2 Type of change

Modification of fixing hole.

4747 / 4748 Minibloc					0118.2181	
creation date	created by	release date	released by	notification no.	revision	page
2013-07-23	hotzar	2013-11-11	hermanur	25283	-	1 of 1

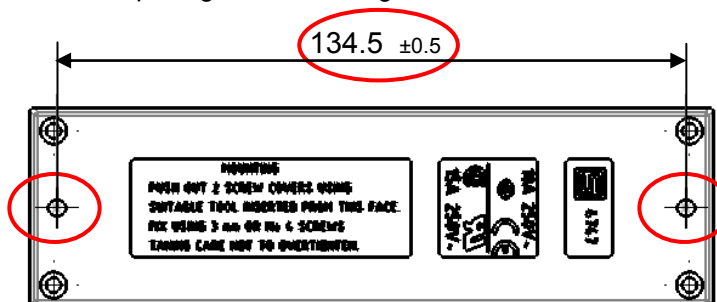
On bottom side, new shape of fixing hole for more hole spacing.

Old: circular fixing holes

New: elongated fixing holes

With the elongated shape of fixing holes, tolerance of hole spacing, 134mm to 135mm, can be met.

New spacing between fixing holes 134mm – 135mm
